# PIC18(L)F26/45/46K40

## PIC18(L)F26/45/46K40 Family Silicon Errata and Data Sheet Clarification

The PIC18(L)F26/45/46K40 devices that you have received conform functionally to the current device data sheet (DS40001816F), except for the anomalies described in this document.

Figure 1. 28-pin SPDIP, SSOP, SOIC

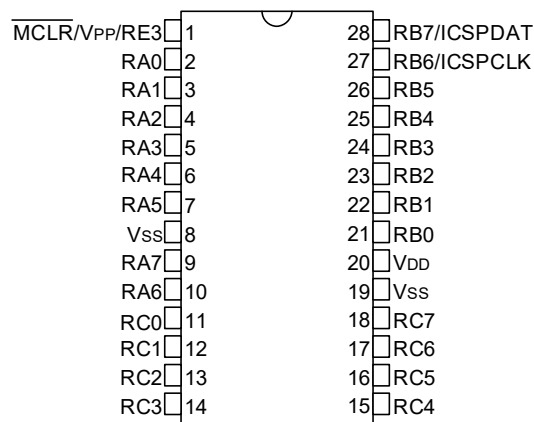
The correct marking for pin 26 on the 28-pin SPDIP/SSOP/SOIC package is **RB5**.

Figure 3. 40-pin PDIP

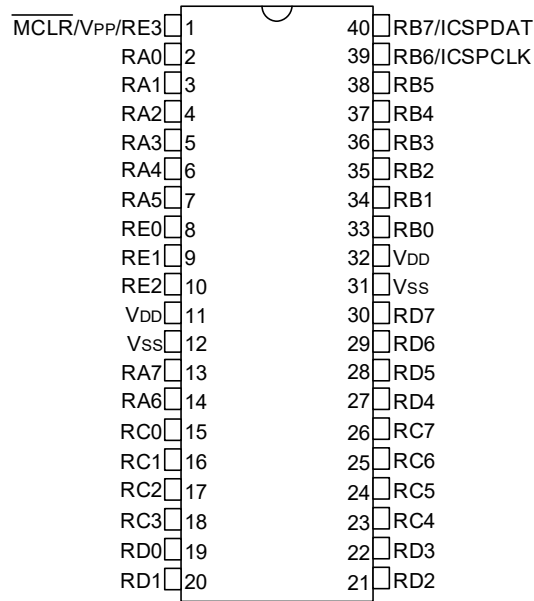
The correct marking for pin 38 on the 40-pin SPDIP package is **RB5**.

**Figure 38-10: ADC Conversion Timing (ADC Clock  $F_{OSC}$ -Based)**

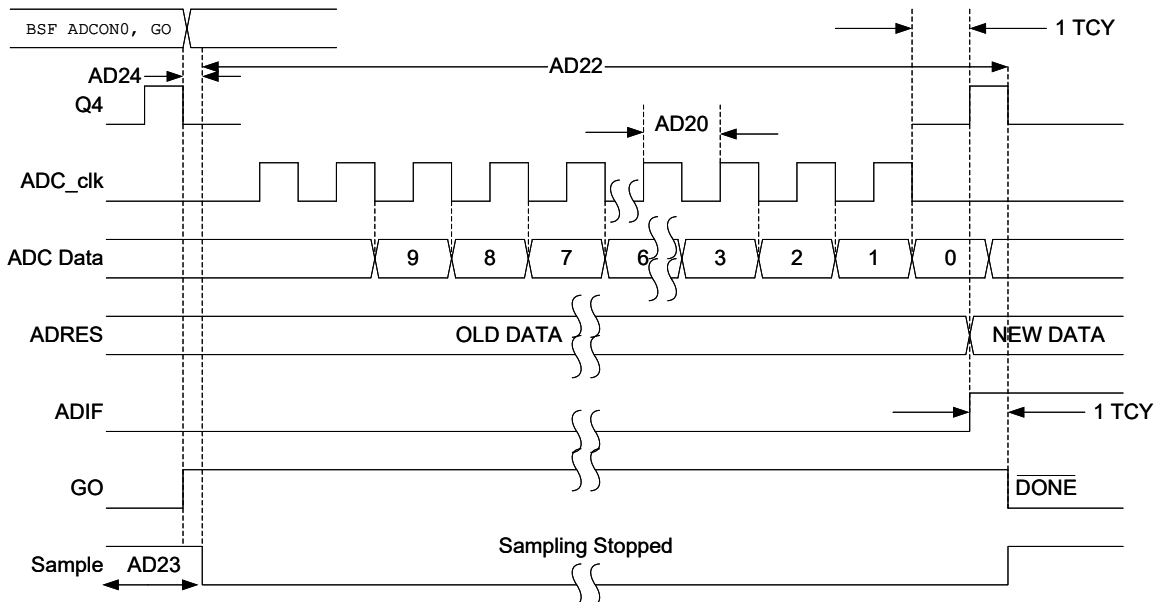
Refer to the images below for corrections of Figure 38-10 and Figure 38-11. Previously, the parameter numbers were incorrect.
